## PLANNING COMMISSION

Monday, September 22, 2014

a. Consider a Site and Design Review & Conditional Use Permit from Verizon Wireless to construct a 100' Monopole with 12 – 8' panel antennas with the tip of antennas at a height of 104', ground equipment installed on a 22' x 3.5' concrete pad, with a 30kW backup generator installed on a 10' x 5' concrete pad, all within a 50' x 50' lease area surrounded by a secure chain link fence with screen slats topped with barbed wire at this unmanned site. **(DR 14-02/CUP 14-01)**

Prepared for the September 22, 2014 Planning Commission Meeting

POR BARLOW – Antenna(s) Centerline (C/L): **100.00'**

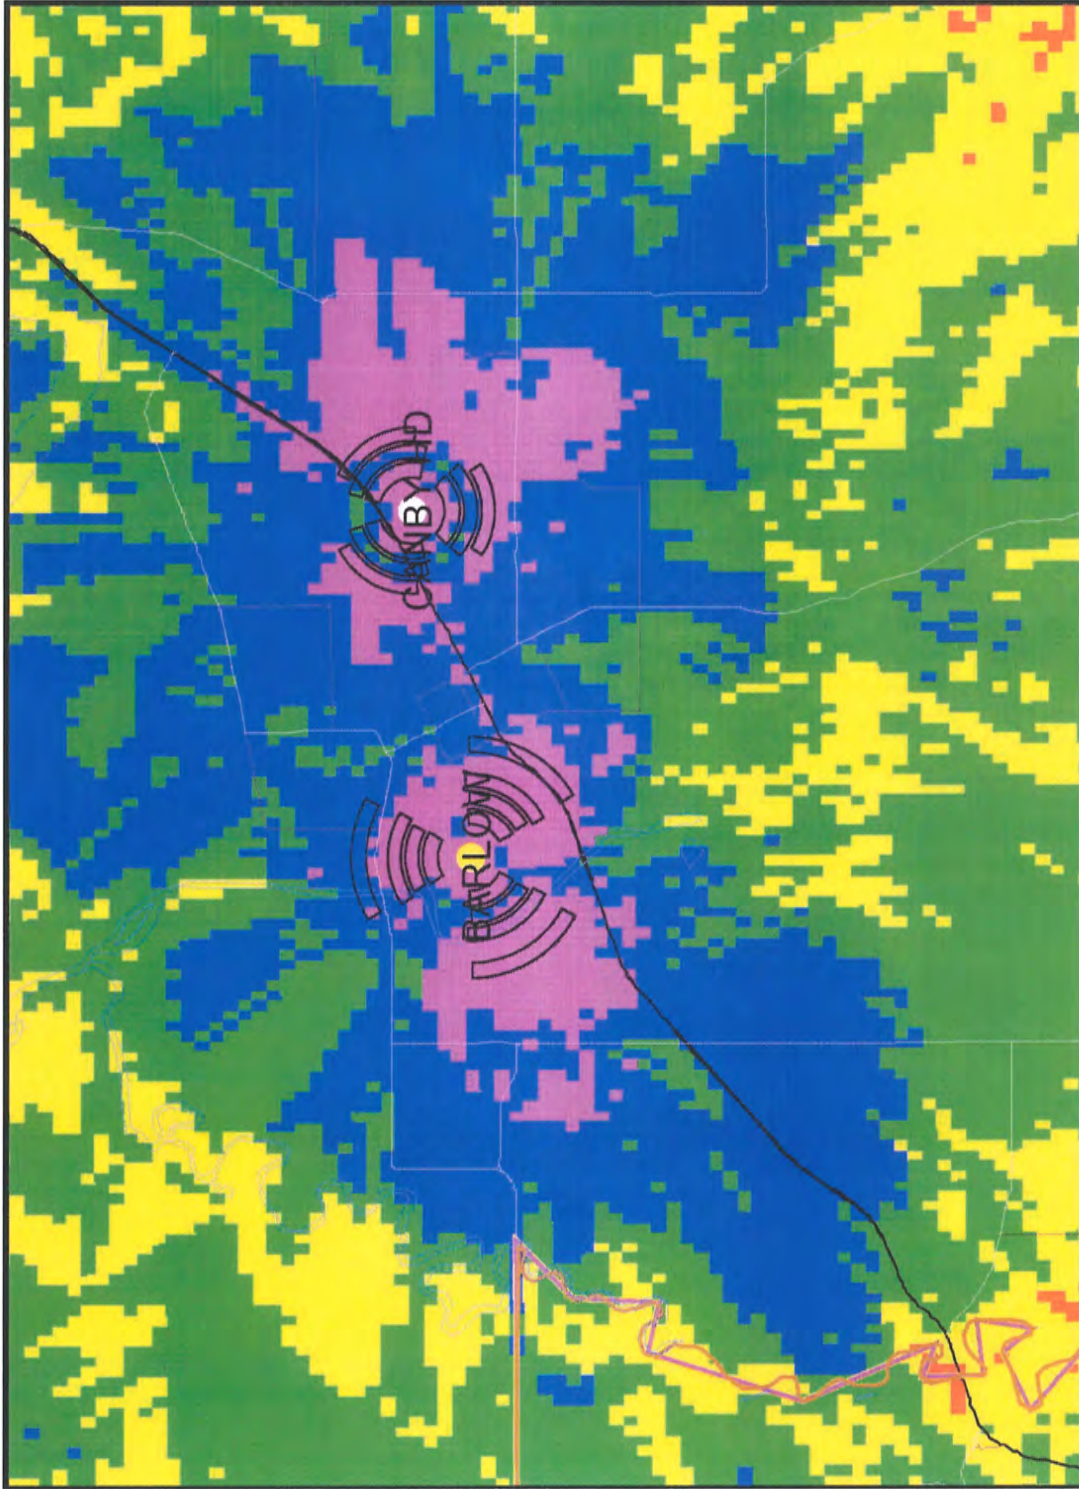
**Findings:** Exhibit G, "RF Engineer's Letter of Explanation" why the proposed facility needs to be located in the general area. Other sites were explored. A willing property owner is needed. The city encouraged consideration of locating on the police building site and evaluation took place. The company chose this site. The applicant states they need a 100' cell tower to meet their coverage goals. It is understood that if the tower were lower at this location, the sought after "coverage" goal would be somewhat less.

Exhibit 3&4 shows coverage/ RF signal emitting of our propose *POR Barlow* site. With our antenna at 100' centerline (C/L), nearly the entire coverage area will be covered by high to moderate RF signal strength, as depicted by the purple, blue, green, and yellow portions of the map. Therefore Exhibit 3&4 meets our design objective for this site; hence the area of coverage is nearly identical to the coverage objective depicted in Exhibit 1. The proposed site in Exhibit 3&4 will provide the additional capacity from propose *POR Barlow* for west of Canby city limit, Highway 99E, Highway 170 and substantial rural area as possible) as depicted in Exhibit 1.

Exhibits 5 & 6 depict how the proposed *POR Barlow* site will be integrated into our network system for that area. Therefore our antenna with a centerline of 100 feet (AGL) will fulfill the capacity objective for *POR Barlow* as depicted in Exhibit 5 & 6. The propose site ensures, RF signal overlaps with adjacent sites to allow continuity of call(s) or "handoff." Therefore a 100' (AGL) antenna centerline is required at the *POR Barlow* site location as shown to provide an uninterrupted service from *POR Wilsonville* site to the north, *SLM Aurora* site to southwest, and *POR Canby* site to the east,. Therefore the *POR Barlow* site will provide the additional capacity for City of Canby and environs.

**PROPOSED SITE PLAN**

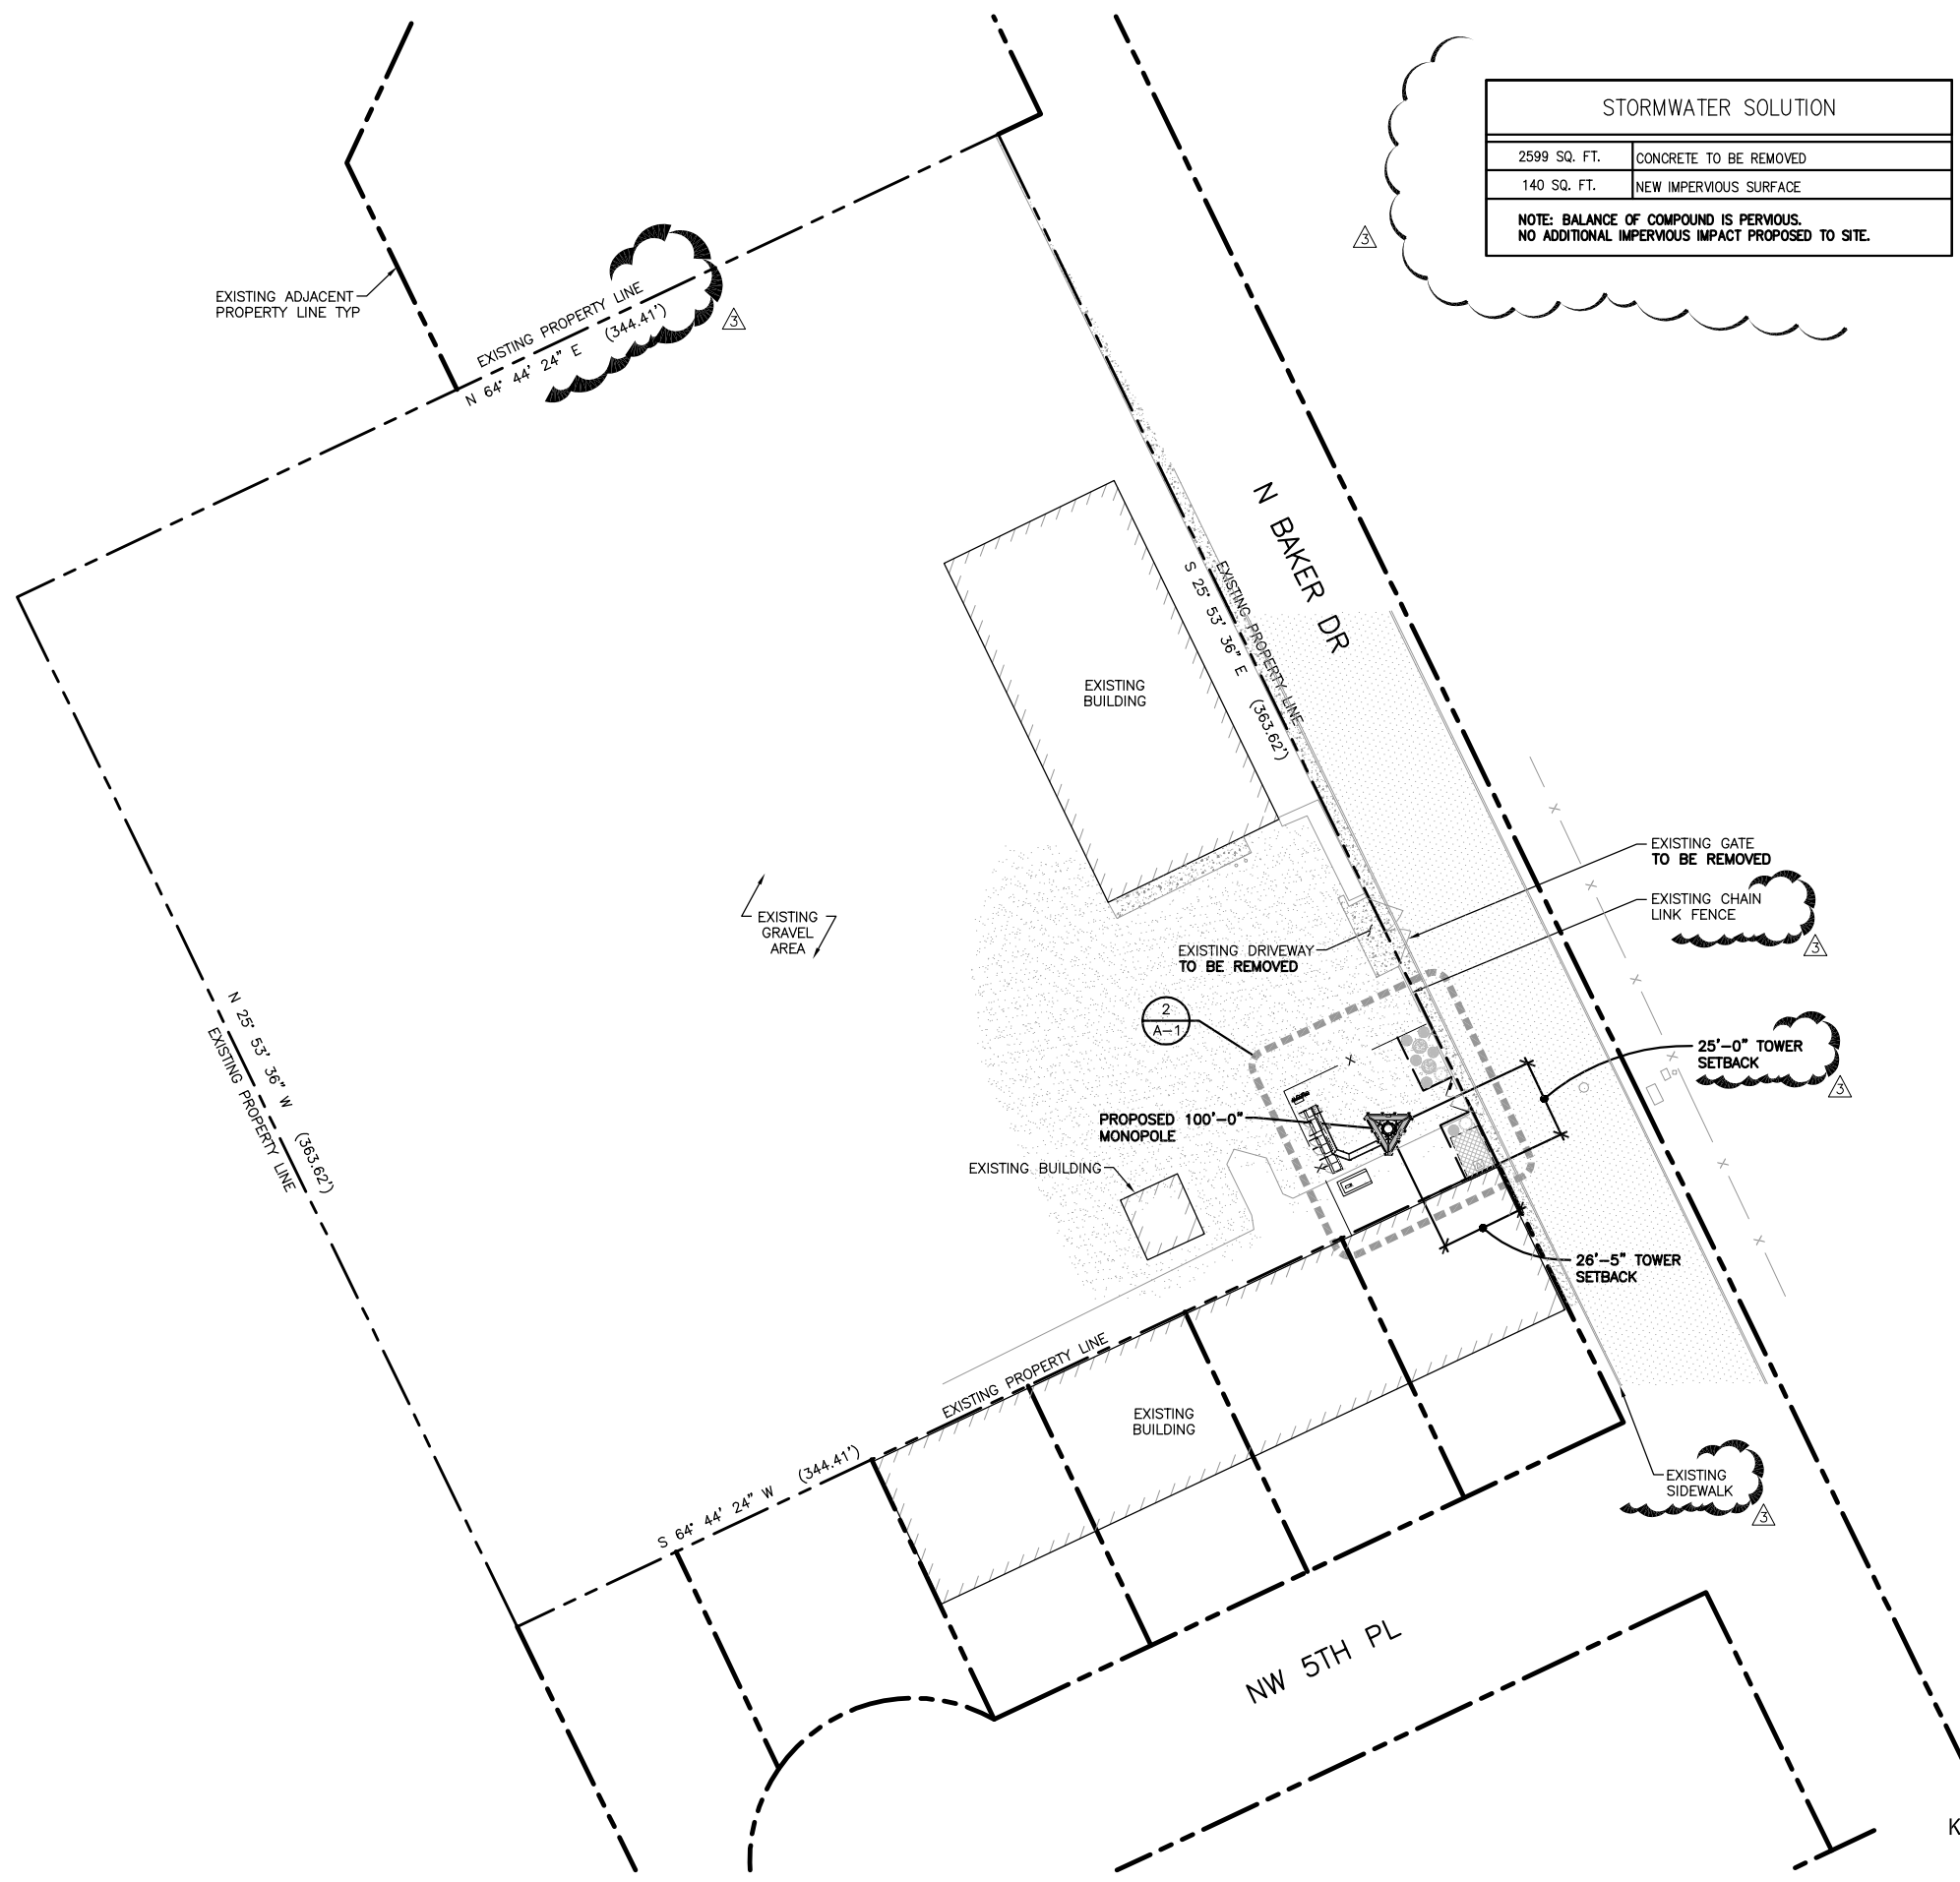
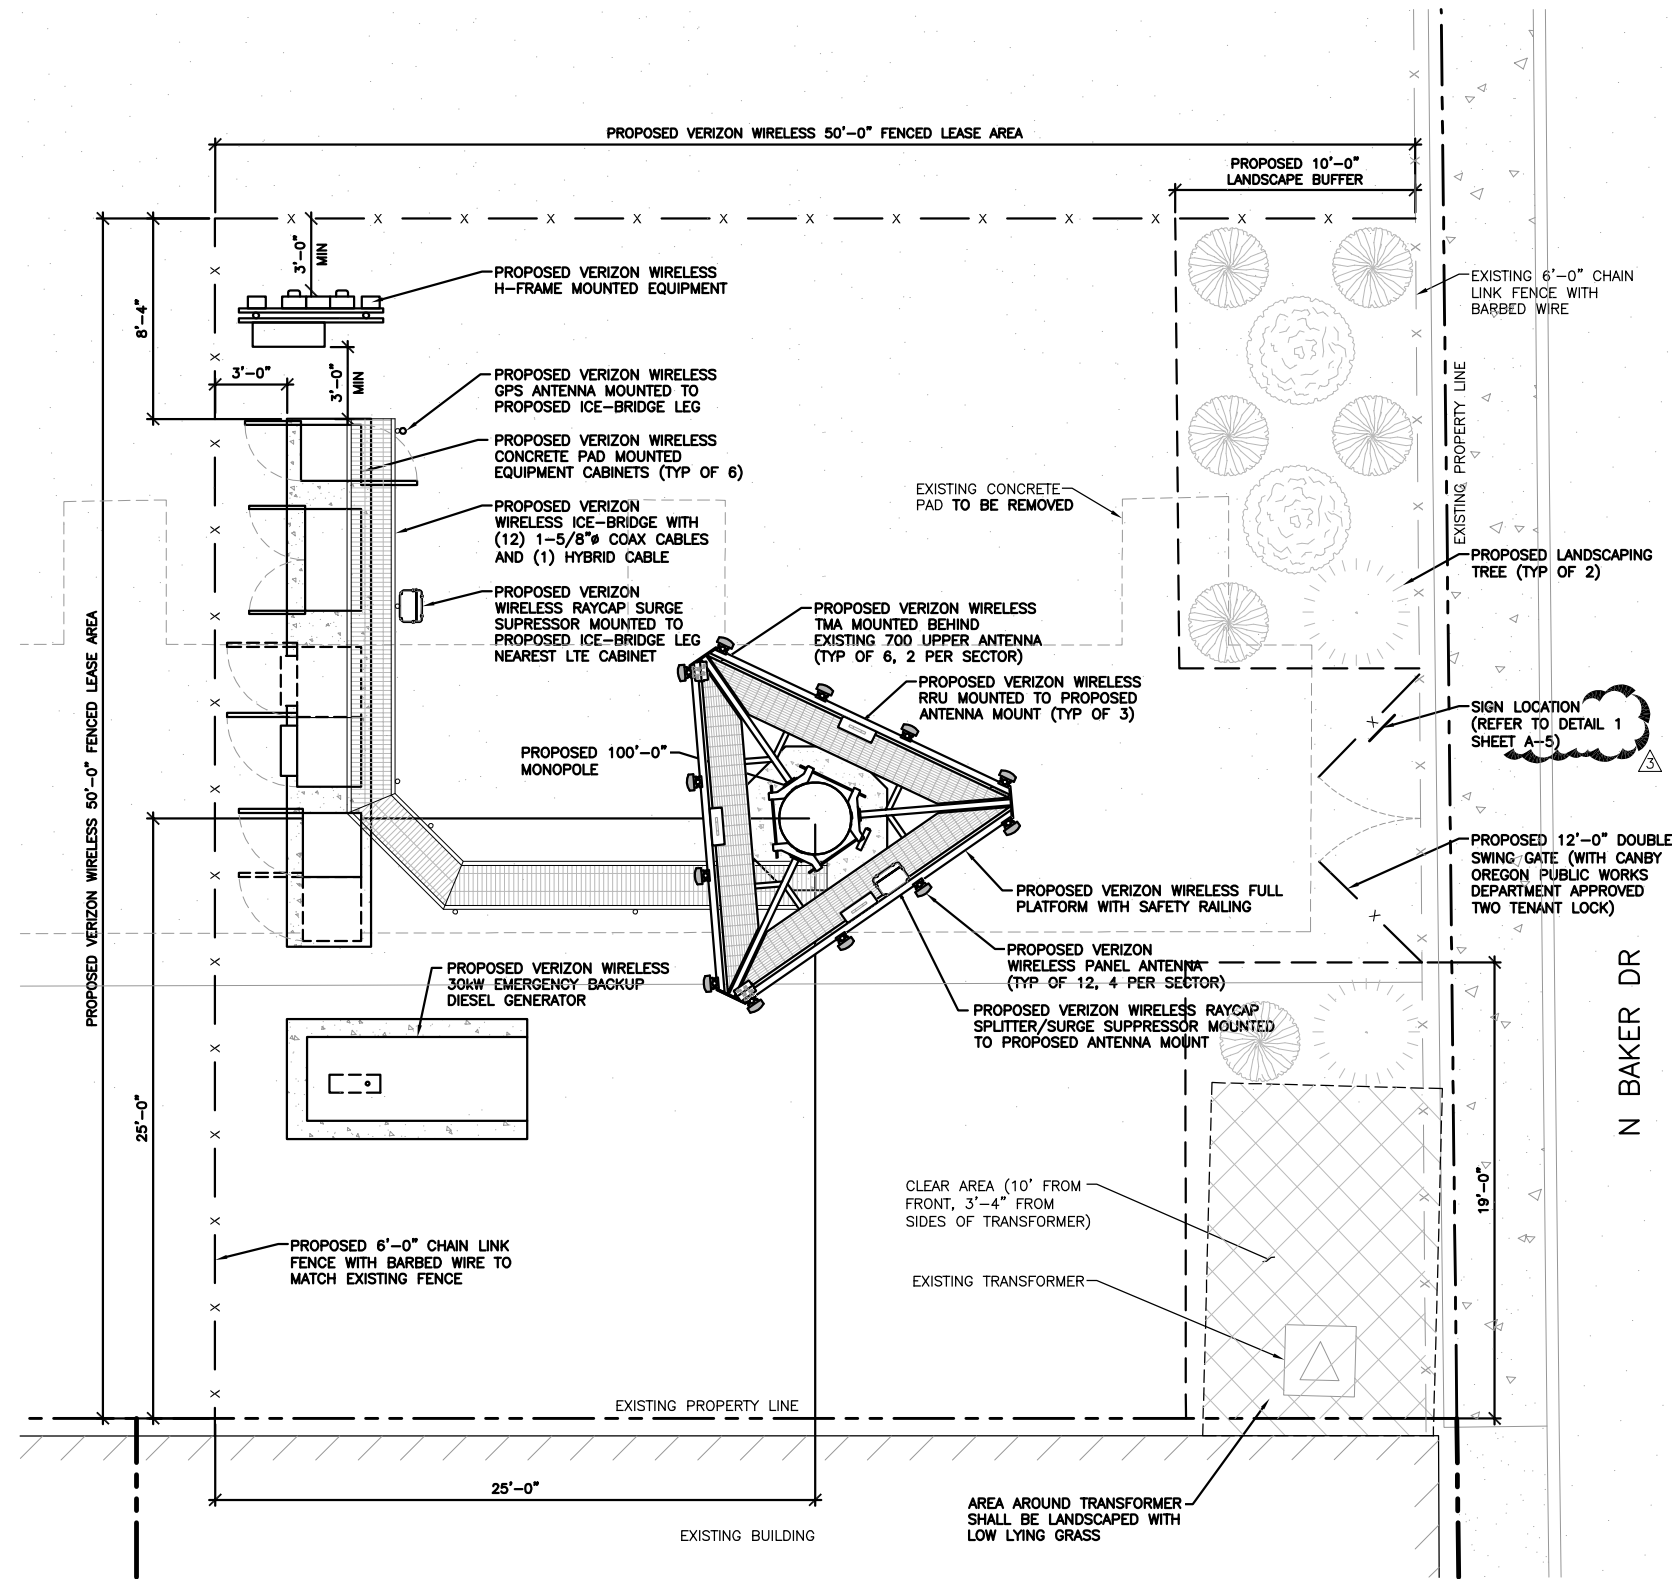
- See "storm solutions" box on drawing C-1. The proposed development of the lease site has been determined to actually reduce runoff characteristics from those that exist today.
- The proposed site is not at an intersection, and the proposed driveway and landscaping meet usual clear vision standards.
- This facility only needs electric and phone service. Access will occur by bore under N Baker Drive. No utility service issues were raised at the pre-application conference, or through a request for comments to utility providers.
- A condition of approval requires City Engineer, Public Works, utility provider approvals.
- No street improvements proposed or required to trigger the requirements of D-F.

**Findings:** A good portion of the existing lease site is a gravel surface. The site plan does not clearing demark the one on-site parking space required. There is certainly room within the lease area for a parking space. It should be on a paved surface in keeping with paving at least the first 20 from the right-of-way line to keep gravel from being tracked into the public street.

**Findings:** The required single on-site parking space is not currently designated by the site plan. A condition of approval to provide a paved driveway should also provide a designated on-site parking space.

**Findings:** The site plan does not clearly delineate the final boundary of landscape area versus existing gravel surfacing, versus the required paved driveway requirement which is needed to also accommodate a single on-site parking space. A condition of approval to submit a revised site plan delineating the presumed extent of these items should satisfactorily meet requirements.

**Findings:** A single on-site paved parking space is required but not currently identified. A revised site plan should delineate this requirement. The driveway must be a minimum of 12 feet wide. An 18 foot long paved drive behind the gate would meet the on-site paved single parking space requirement.
